42 HONEYSUCKLE DRIVE COTTAGE CREEK PRECINCT NEWCASTLE

NEWCASTLE CITY COUNCIL
DEVELOPMENT APPLICATION

ARCHITECTURAL DESIGN RESPONSES

MAY 2018
REV B

4.2 HOTEL COMPONENT VENTILATION

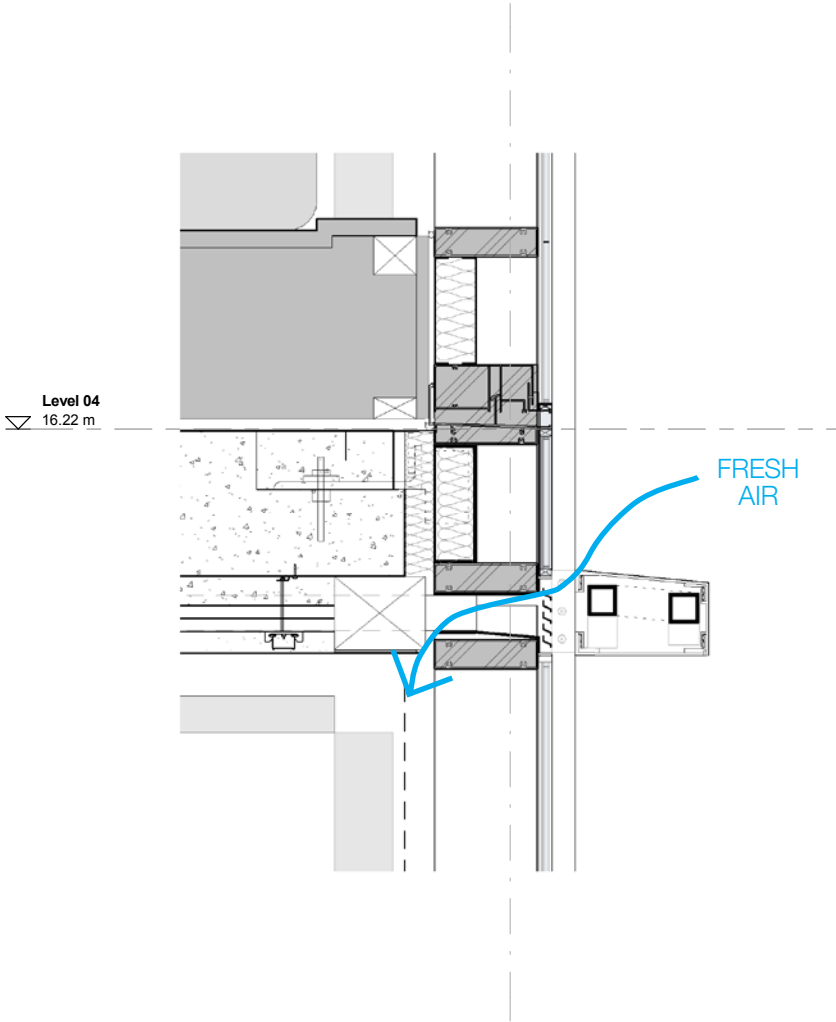
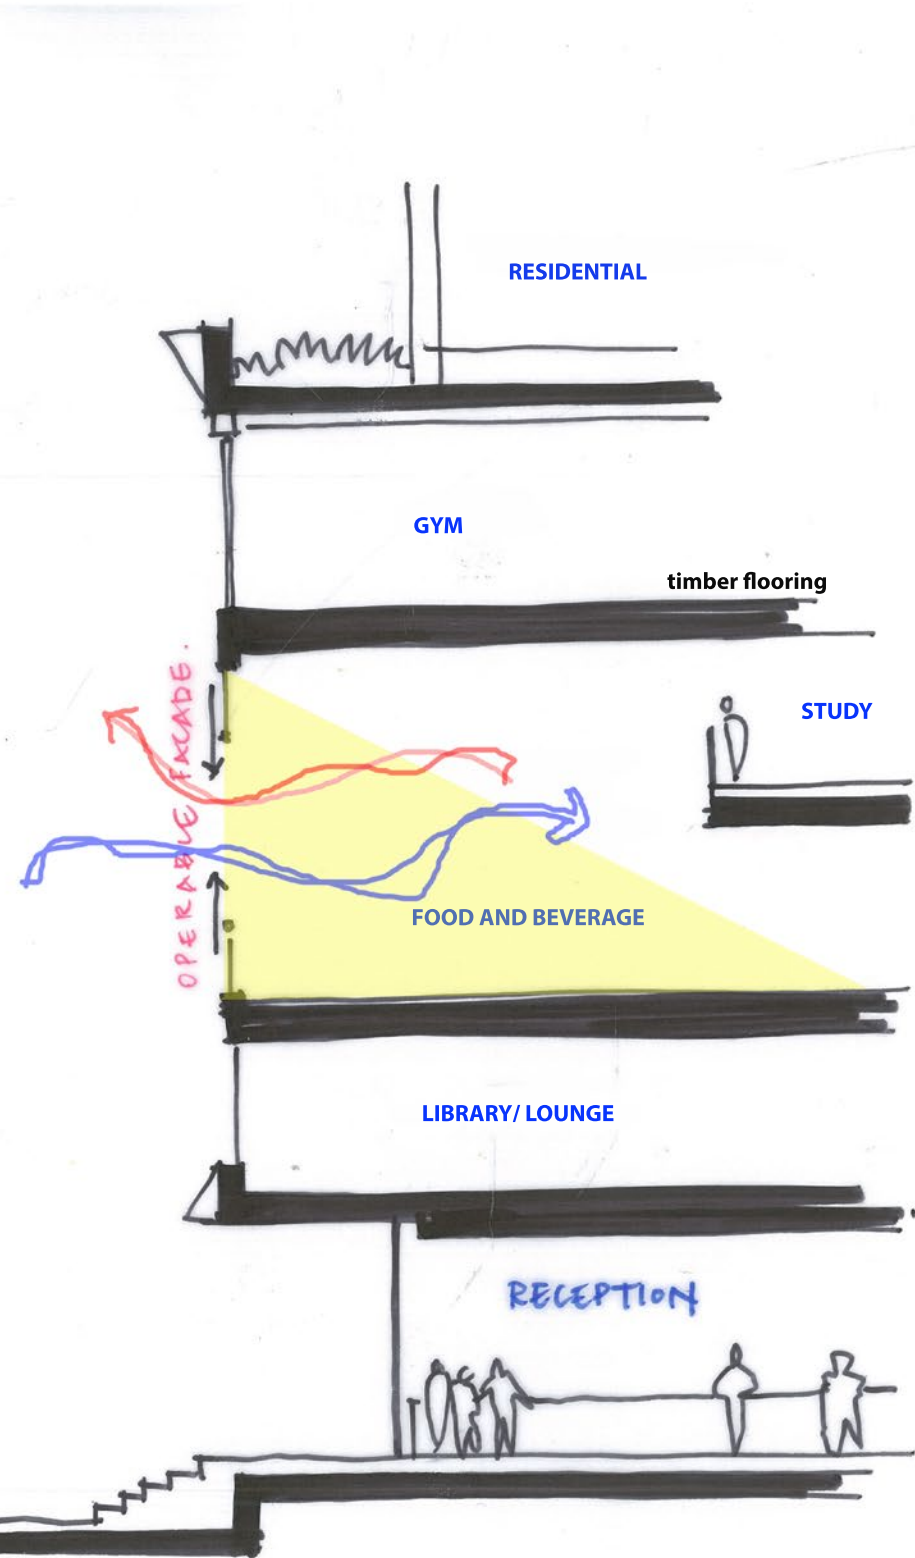
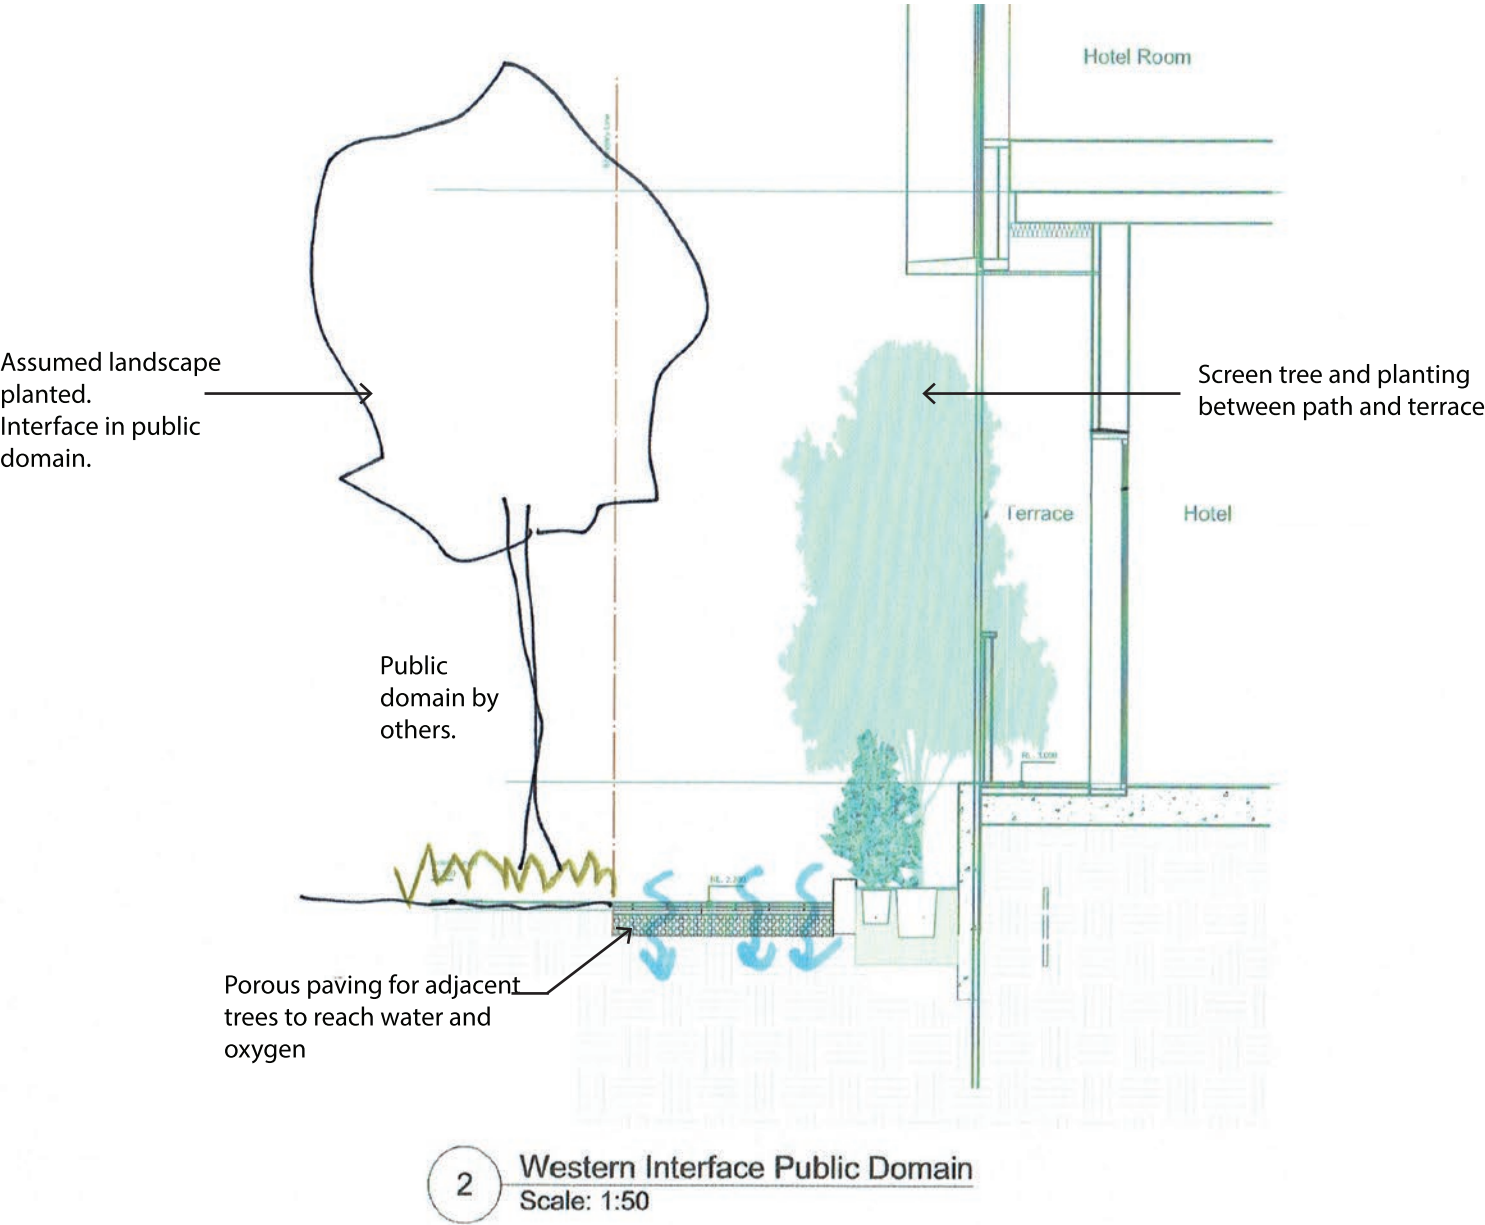
Provide the opportunity for natural ventilation to the hotel rooms and communal hotel spaces including lounge, gym and food and beverage areas

The LN hotel design model and ventilation strategy, used amongst a number of hotels, is to provide large fixed windows at the bed space at the end of the plan and the room is then conditioned accordingly by use of a fresh air intake at the facade line.

The hotel communal spaces situated at the corner North West corner of the site positioned above the entry has a guillotine type window at levels 2 and 3 with a double height space behind which will provide natural ventilation through the space.

Furthermore, the same air-path utilised for the aforementioned supply (outside-air) ventilation, by virtue of its design, will provide make-up air for the exhaust system directly from outside even if the air-conditioning system is switched off. This approach will result in more effective ventilation of the hotel rooms.

6.0 GROUND FLOOR FLOODING

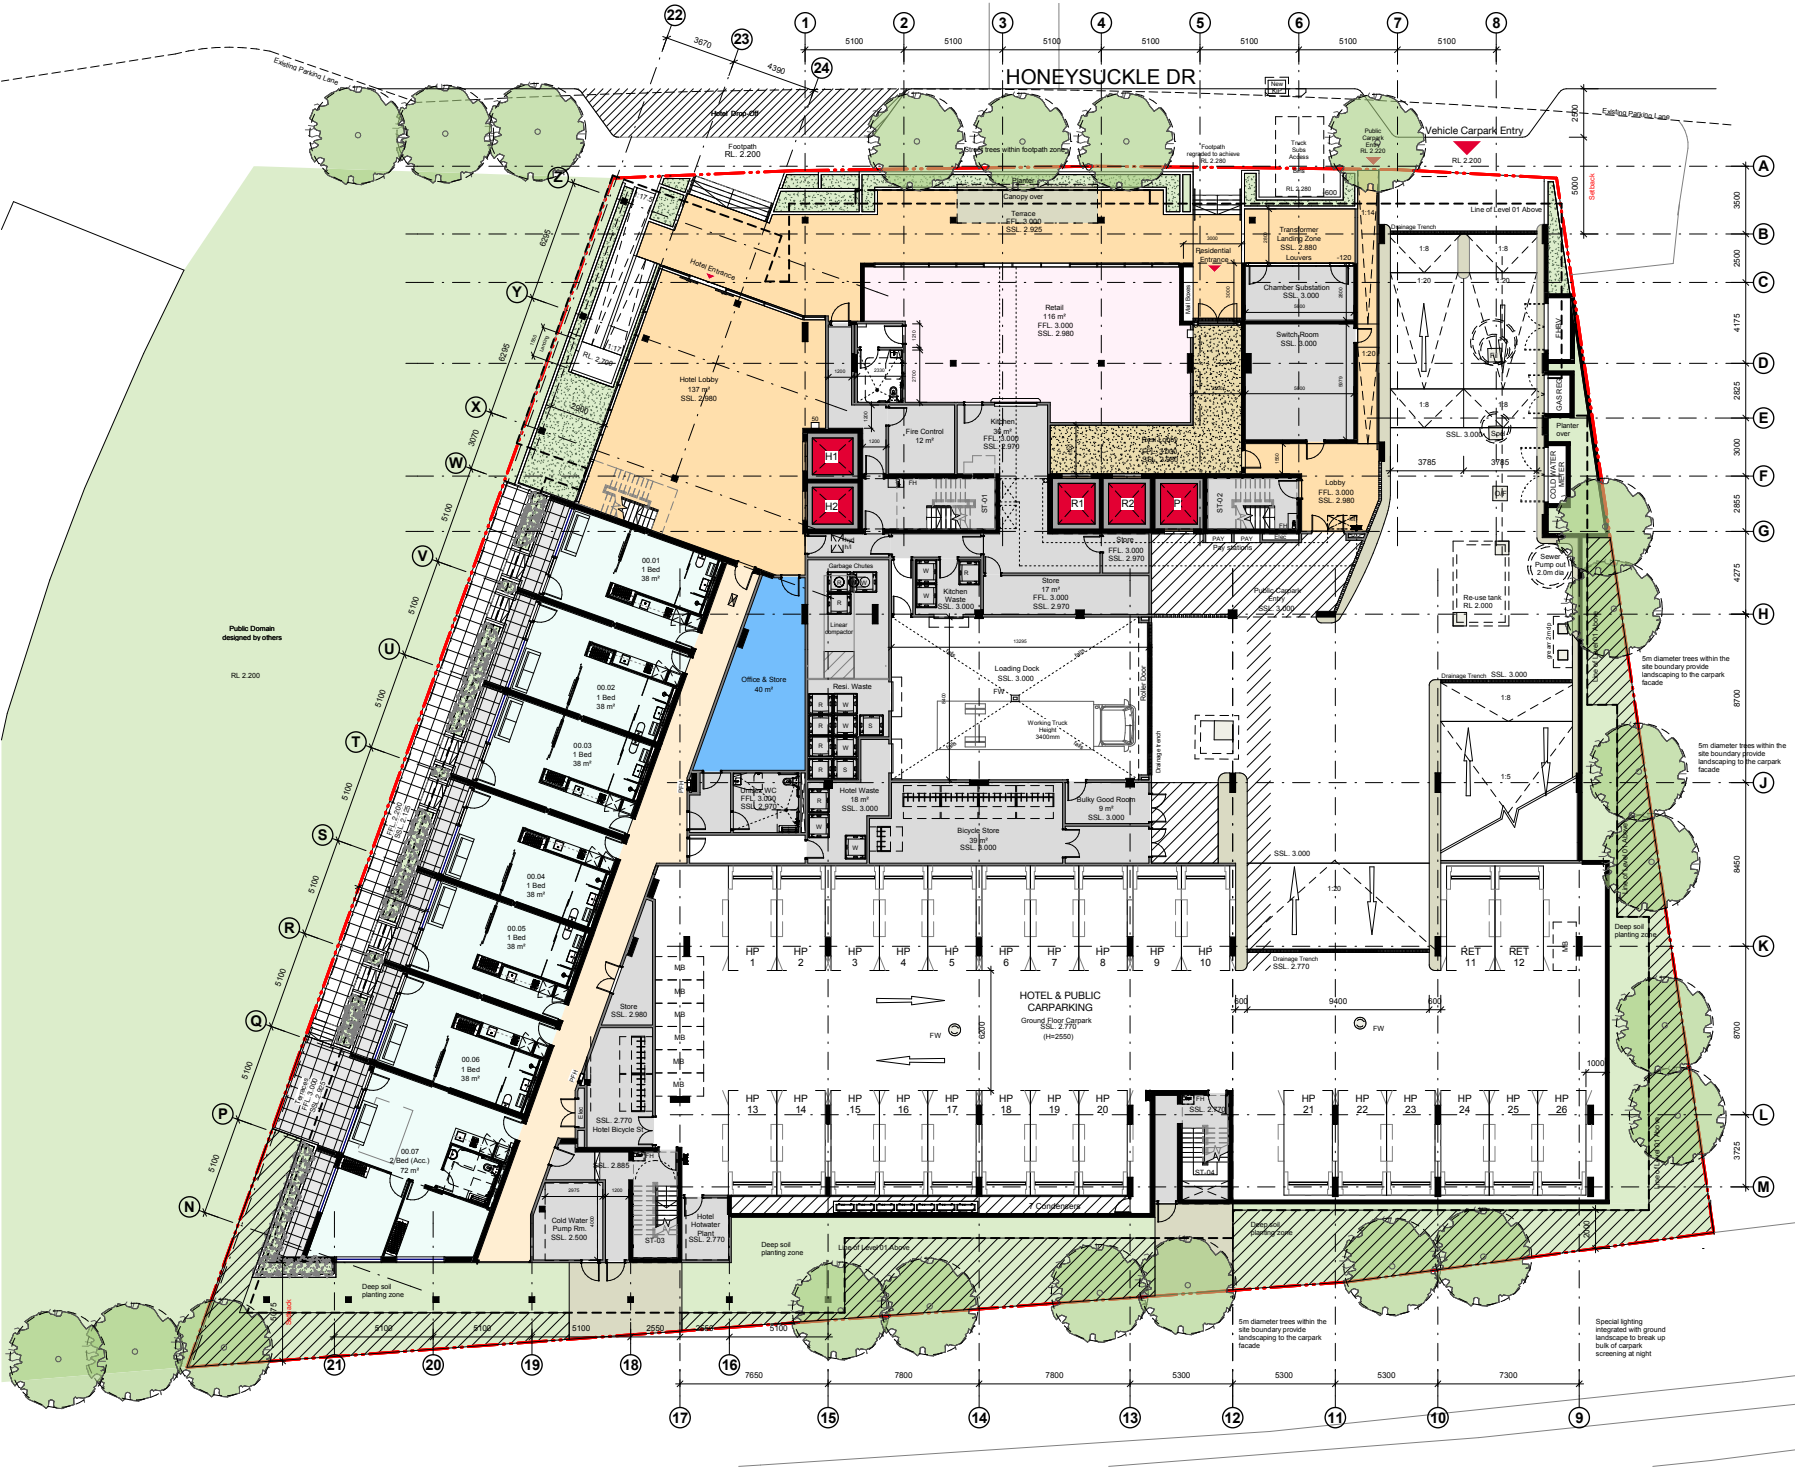
The ground floor level is generally acceptable, however areas such as the cold water pump room, residential bicycle storage, bulky goods, and kitchen storage will need to have electrical fixtures such as power points, light fittings and switches are sited above the flood planning level.

Agreed, all electrical fixtures will be located well above the floor planning level of 2.9m.

The access entry from the ground floor carpark loading dock to Lift 'P' has a floor level at 2.5m AHD. The floor level of the residential lobby opposite is 3.00m AHD. Generally, lifts are set at flood planning level (i.e. 2.9m). The applicants will need to confirm if lift 'P' opens to the residential lobby and confirm the finish level for lift 'P' from the loading dock entry

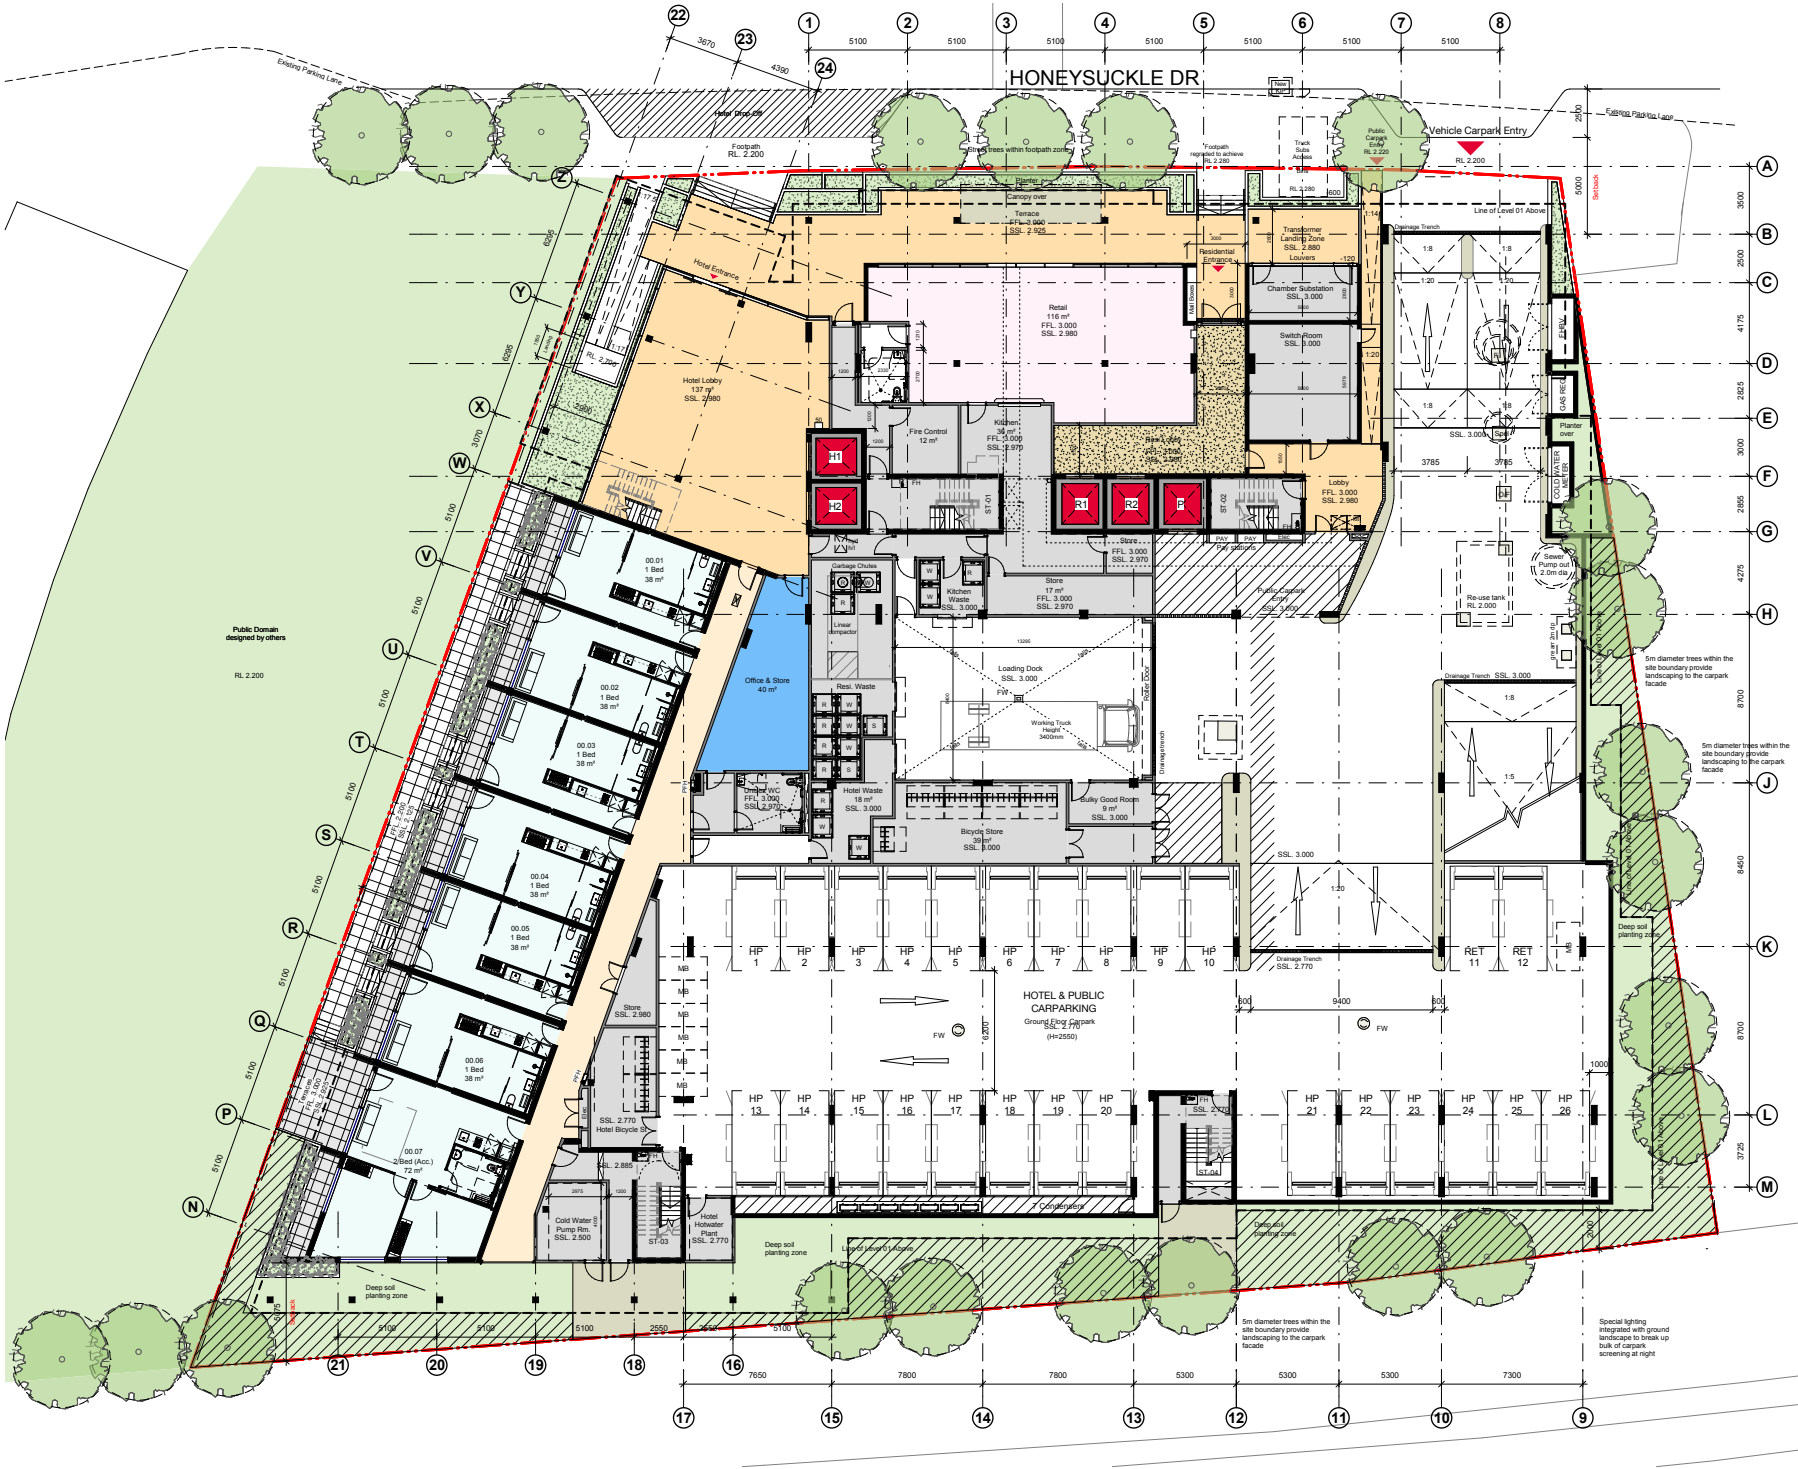
The submitted plans do not clearly identify the visitor parking for the residential units, the allocation of parking for the retail unit, hotel parking, public parking and staff parking.

Refer to attached plans within the appendix that clearly indicates the visitor, retail, hotel, staff and public parking.
Note: Retail customer, staff and maintenance will be rolled into Hotel/Public parking bays.
